Addendum Number 2

Date: 7/11/25

Project: Water Treatment Facility Project

Owner: Trinidad Rancheria

PROCESS & INSTRUMENTATION DIAGRAM	
TITLE	
DRAWN BY	K. RODRIGUEZ
CHECKED BY	S. JOHNSON
APPROVED BY	S. JOHNSON
DATE	12/7/23
DRAWING NO.	P100
'B' SIZE SCALE	NONE
JOB NO.	P2311096
SHEET	1 OF 2
REVISION	E

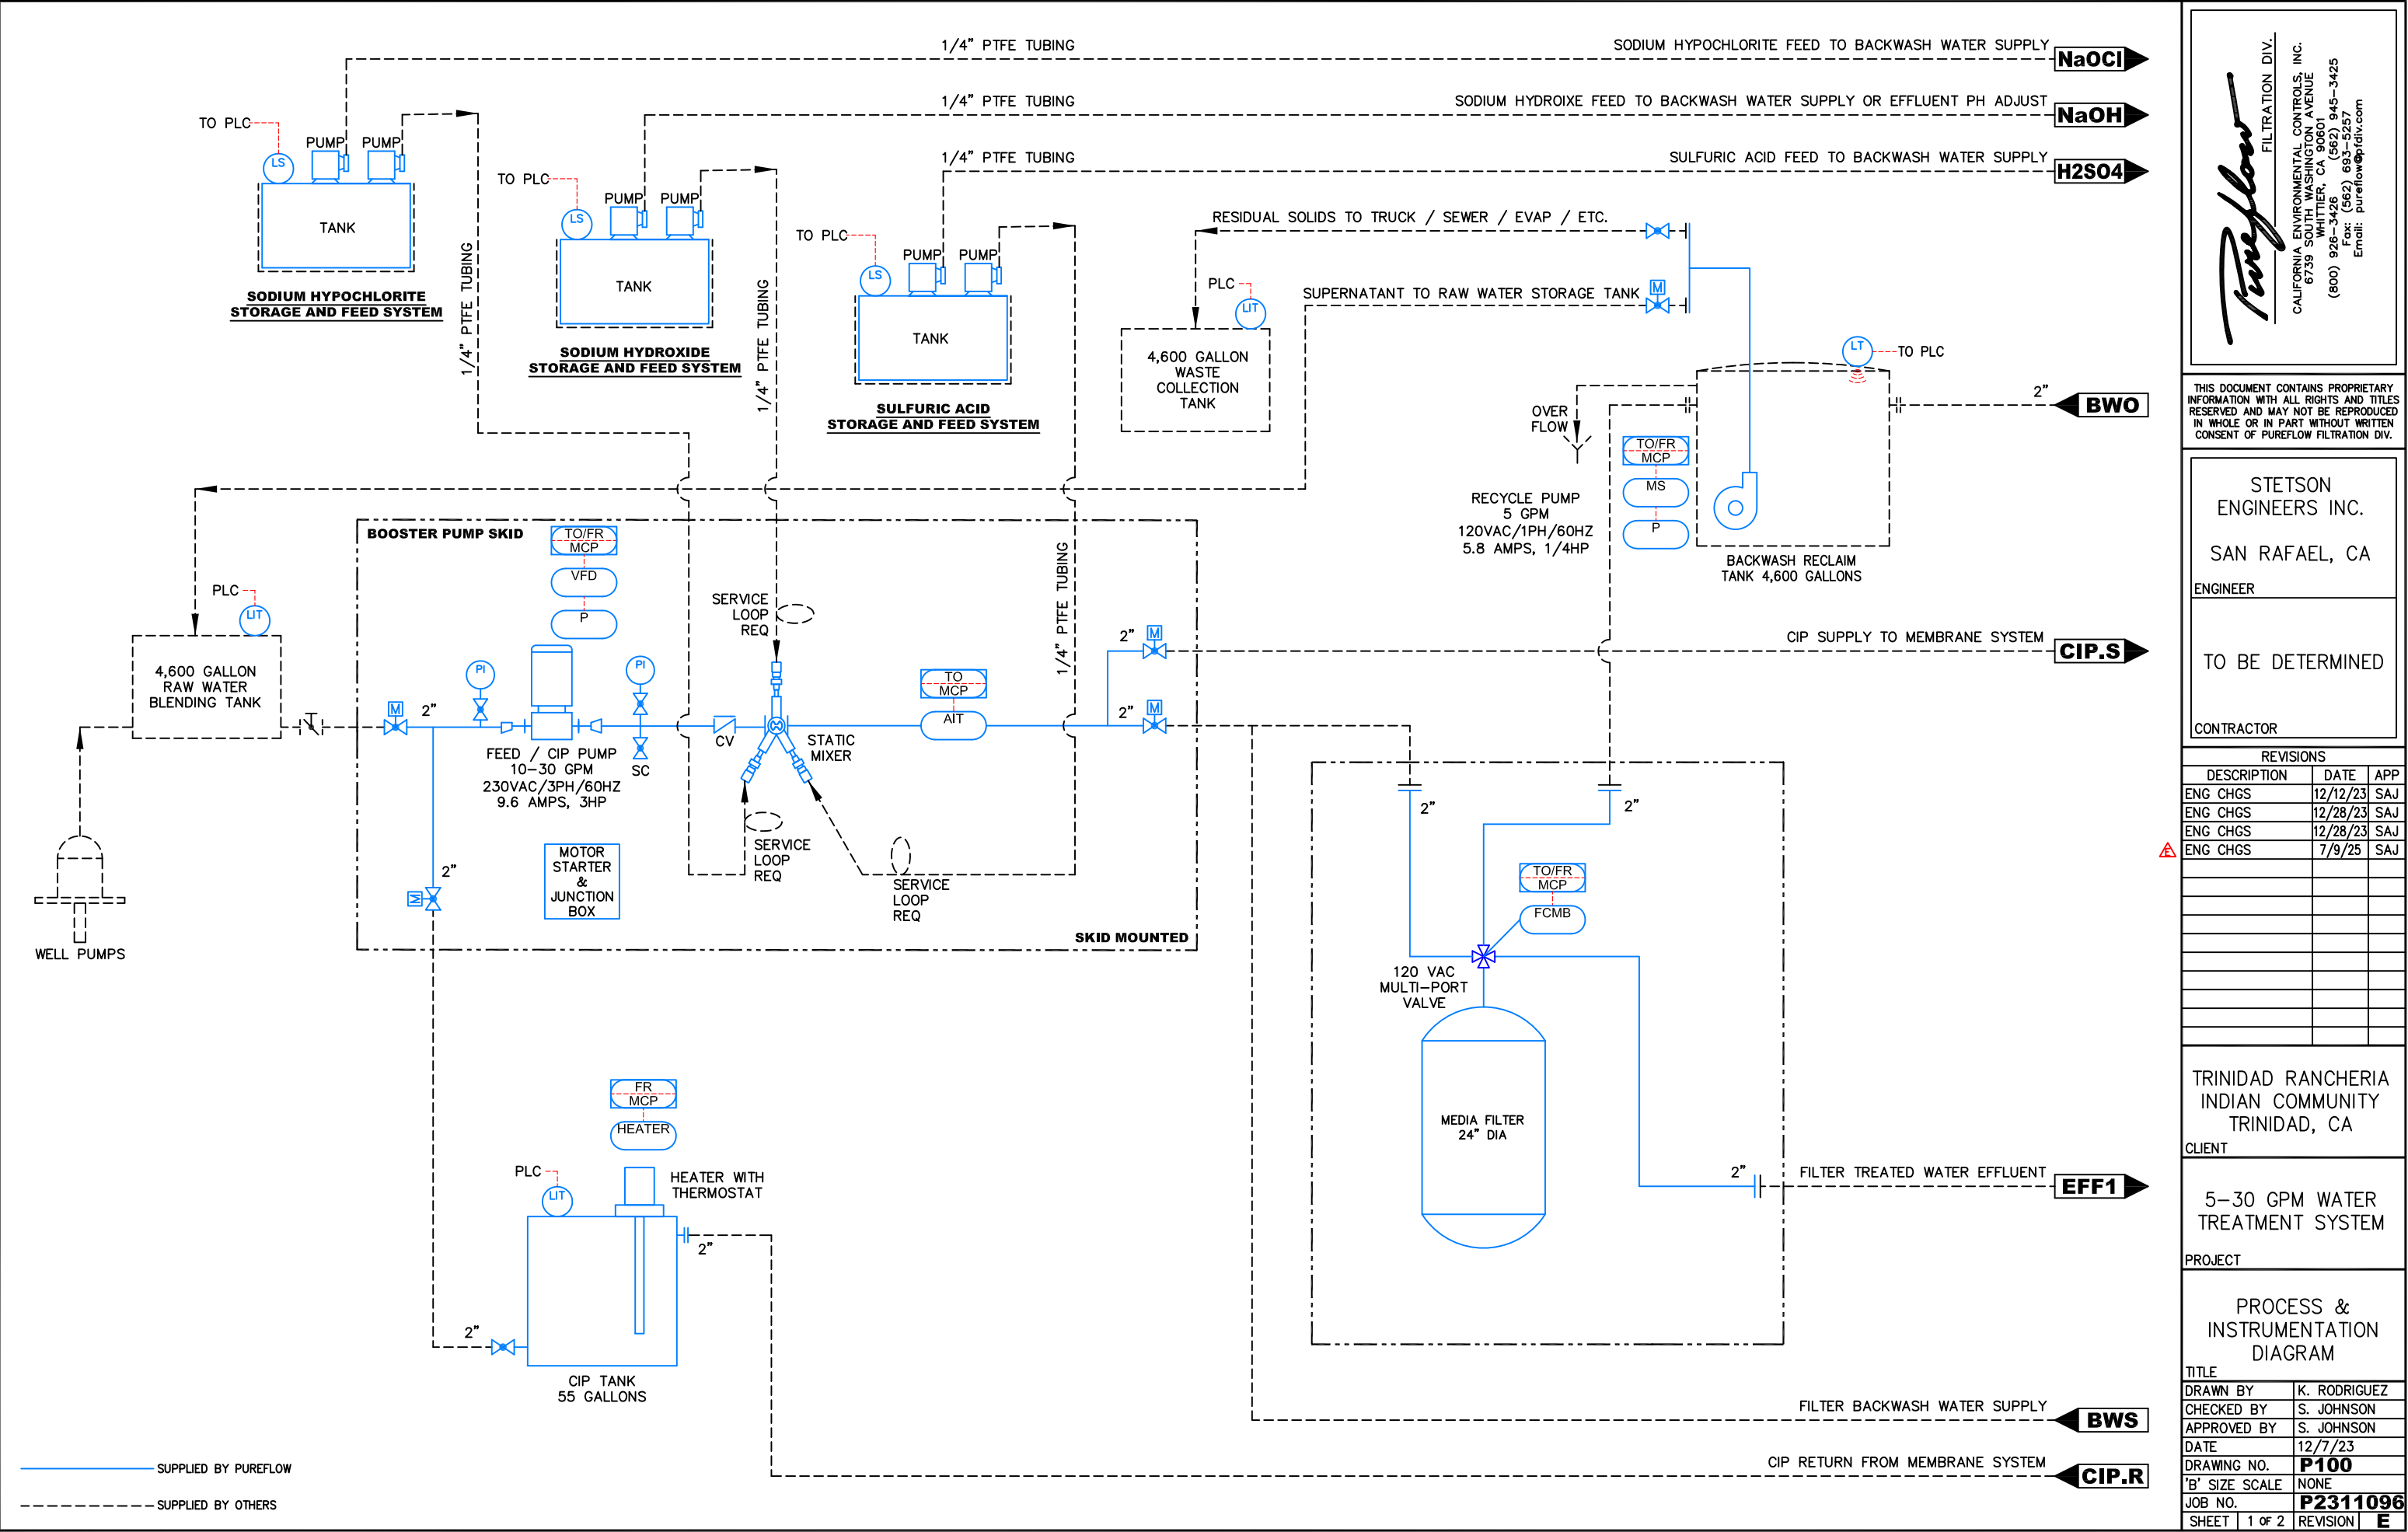
Attached is an amended version of our Project P2311096 drawing P100 showing the voltage and the Amp ratings for the pumps which are the two major Amp draw items.
Cheers

PROCESS & INSTRUMENTATION DIAGRAM	
TITLE	
DRAWN BY	K. RODRIGUEZ
CHECKED BY	S. JOHNSON
APPROVED BY	S. JOHNSON
DATE	12/7/23
DRAWING NO.	P100
'B' SIZE SCALE	NONE
JOB NO.	P2311096
SHEET	2 OF 2
REVISION	E

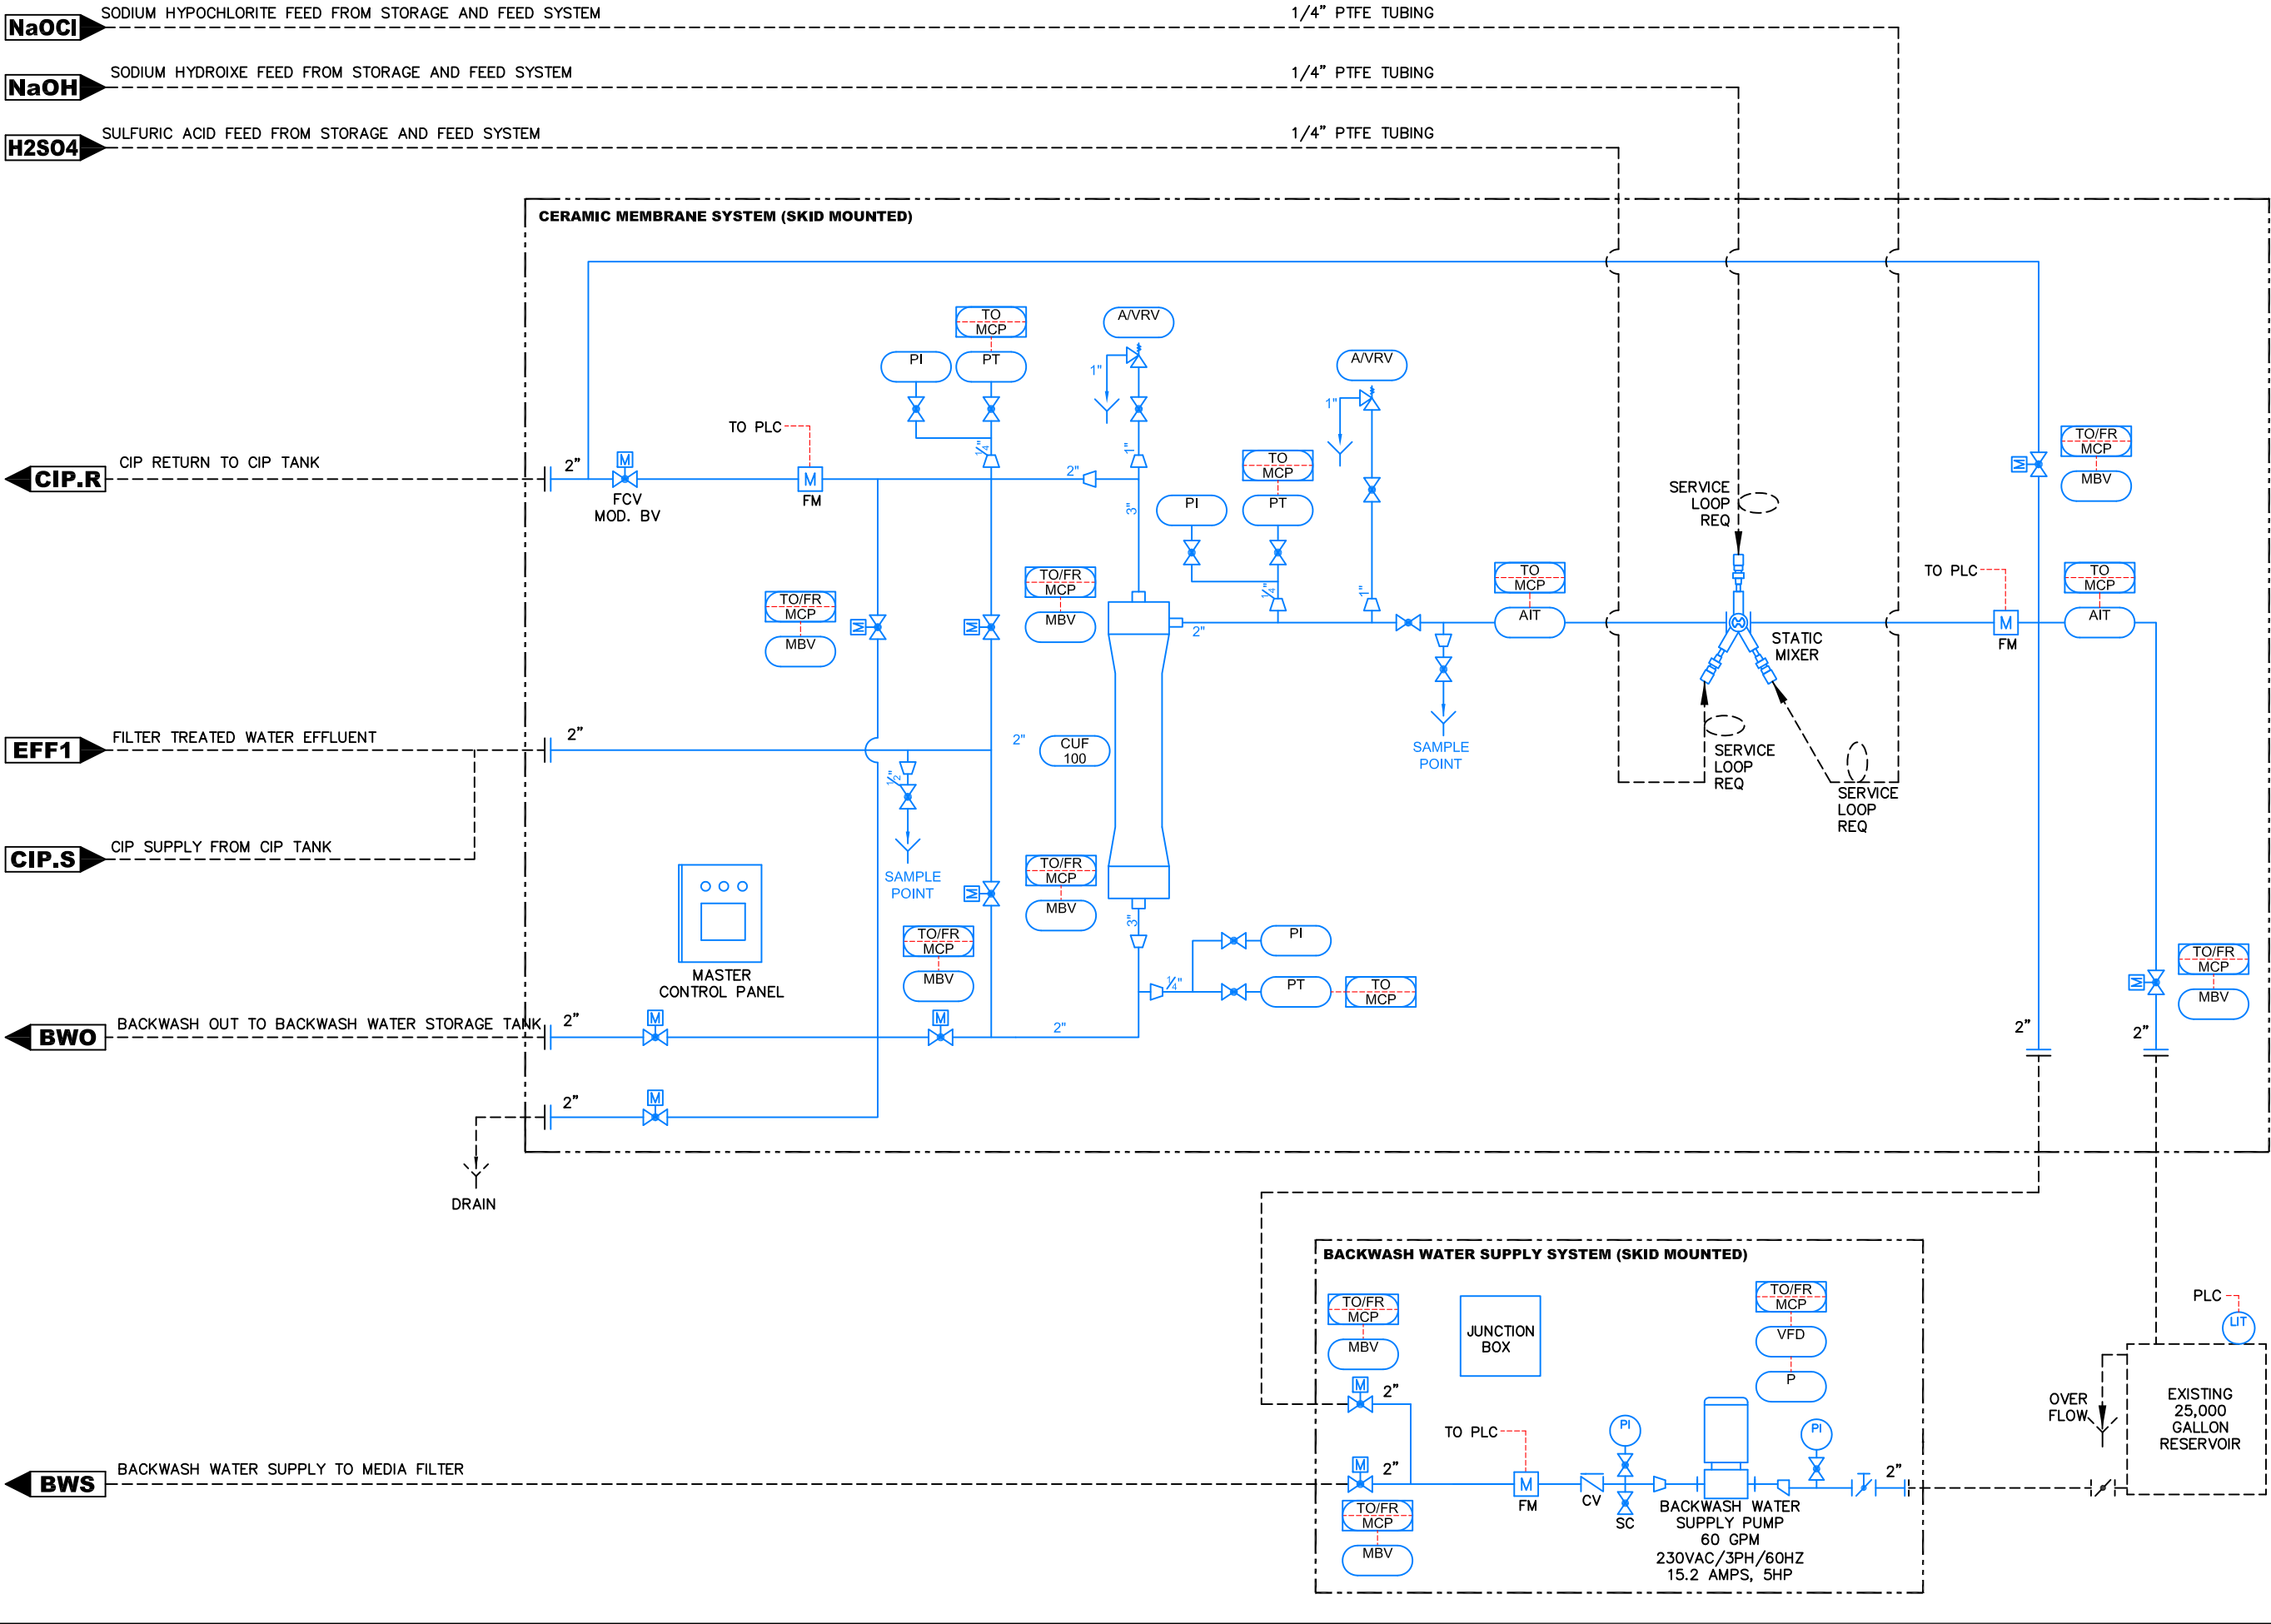
Following up on our conversation regarding power for the Trinidad Rancheria WTP project. Although the Pureflow P&ID show 480V/ 3PH/ 60HZ, inform the contractor we can supply 230V/3PH/60HZ.

- Booster pump 3 HP at 230V/3PH = 9.6 Amps (230V/ 1 PH/ 34 Amps)
- Backwash Pump 5 HP, 230V/ 3PH = 15.2 Amps (230V/ 1PH/ 54 Amps)
- Immersion heater for CIP system for Ultra filtration cleaning, 5 to 10 Amps
